CITY OF PORTLAND, OREGON

Staff Presentation to the **Portland Design Commission**

1st Design Advice Request EA 16-130513 DA

Multnomah County Central Courthouse

Discussion Items (per Memo)

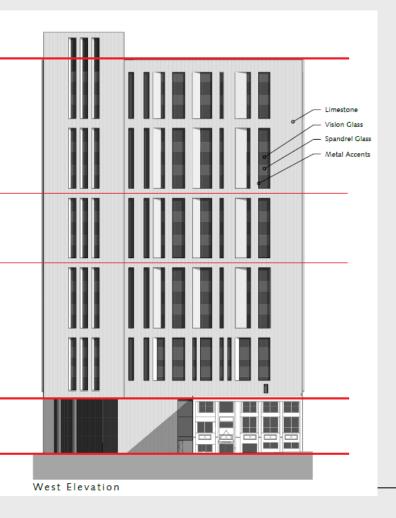
Ground Floor

Madison – highest street classification, east ½ not active/transparent

Naito – sallyport ingress, no activity, little glazing, across from major City Park

Jefferson – sallyport egress no activity, all opaque, loading AD

Overall Massing & Composition

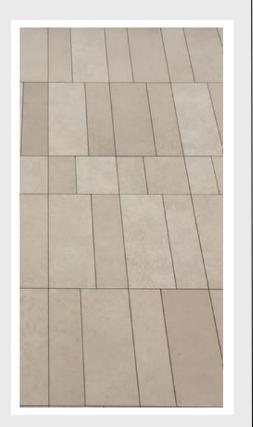
CCFDG C5 - Design for Coherency CCFDG C7 - Design Corners that Build Active Intersections

Strong parti but hierarchy of views at expense of ground floor Relationship between two buildings:

- Stronger or more distinct
- Connections (viewing garden with metal gate)

Exterior Materials

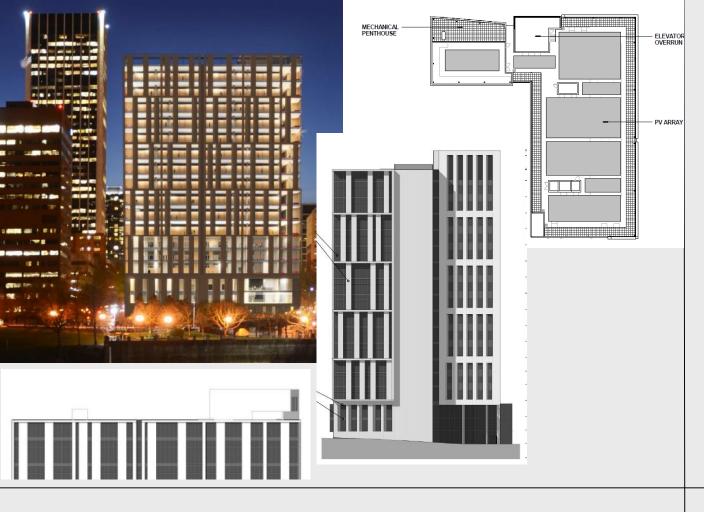
CCFDG C2 - Promote Quality and Permanence in Development

Primary - Limestone & curtainwall (durable & high quality)

Size & orientation of limestone panels

Other materials – storefront, punched windows, metal accents

Rooftop

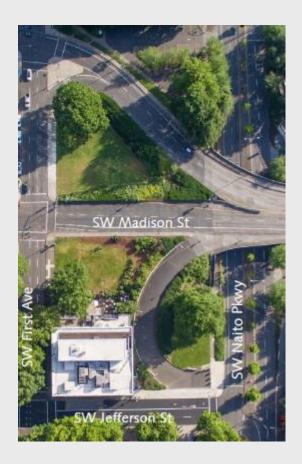
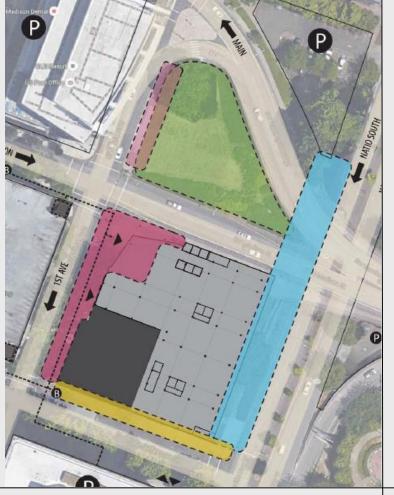
CCFDG C11 - Integrate Roofs & Use Rooftops

Bridgehead location & 300' height - dominant skyline feature

Rooftop elements - thoughtfully designed to integrate utilitarian element in overall design

Successful examples - First & Main and Park Avenue West Tower
